**Modular units for machine tool construction –
Multi-spindle heads – Casing and input drive shaft
dimensions**
AMENDMENT 1

Amendment 1 to International Standard ISO 2912-1973 was developed by Technical Committee ISO/TC 39, *Machine-tools*. It was submitted directly to ISO Council, in accordance with clause 5.10.1 of Part 1 of the Directives for the technical work of ISO.

Figure 2 – Input drive shaft

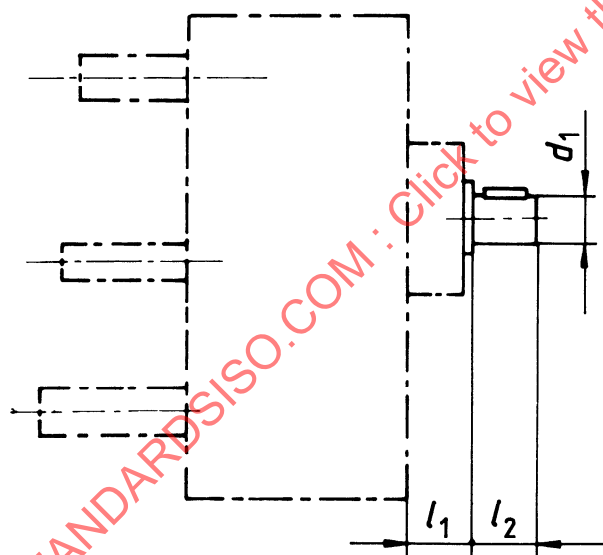
Figure 2; and table 2.

Delete the existing figure and table and substitute the following.

Table 2 — Dimensions of input drive shaft

d_1	tol.	l_1^*	l_2
28	j6	40	60
38	k6	50	70
42	k6	65	70
48	k6	80	85
60	m6	100	110

* Mounting dimension given for information only.
